Supporting information for comments on transmitter power excursion

Supporting material for D3.1 comments #83, 84, 85-88

OS vs. OMA for 800G-DR4:

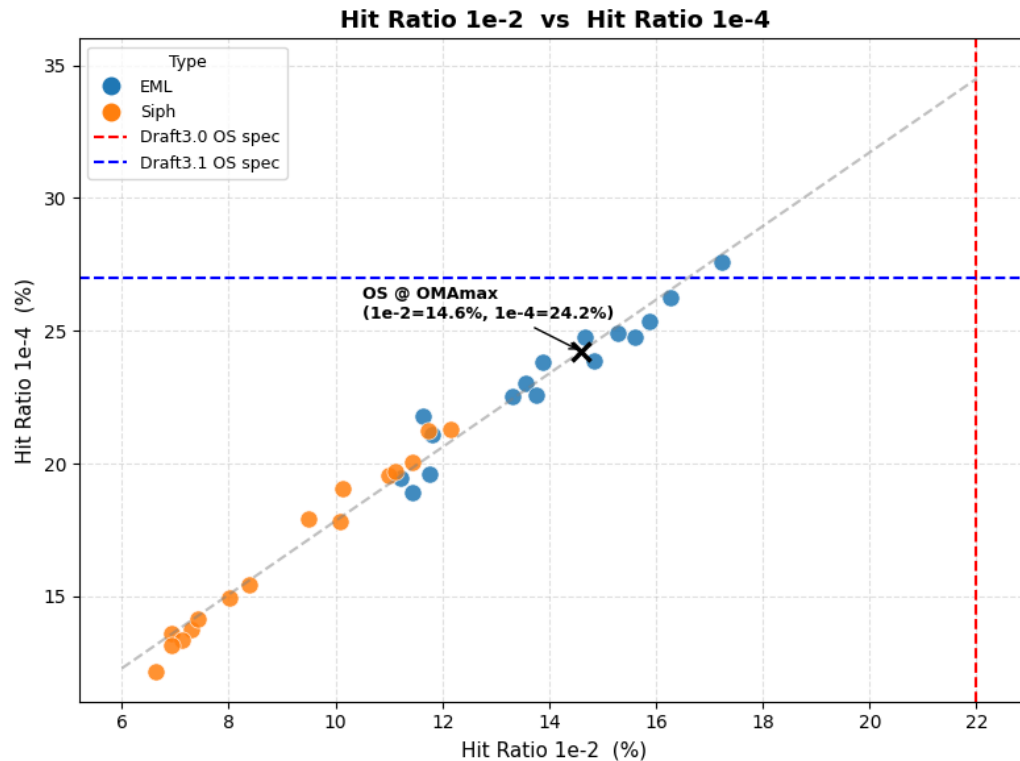
OS(max) = 22%

TPE(max) = 2.3 dBm

OS = 14.6% at OMA(max) = 4.2 dBm

Comments #85-88: Proposed maximum TPE specs at 10^{-4} hit ratio

- Based on the TX overshoot data shown in [rodes 3dj 01b 2605](#), a value of 14.6% OS at OMA(max) at 10^{-2} hit ratio is equivalent to a value of 24.2% at 10^{-4} hit ratio.
- Using the value of 24.2% at OMA(max) results in the TPE values for 3dj optical PMDs shown below in red.

PMD	OMA_max (dBm)	Pavg_max (dBm)	OS_max	TPE_max (dBm)	Max OMA @ TPE_max (dBm)	OS @ OMA_max
800G-DR4	4.2	4	27%	2.90	4.04	24.2%
800G-FR4-500	4.8	4.9	27%	3.50	4.64	24.2%
800G-DR4-2	4.2	4	27%	2.90	4.04	24.2%
800G-FR4	4.8	4.9	27%	3.50	4.64	24.2%
800G-LR4	5.7	5.5	27%	4.40	5.54	24.2%
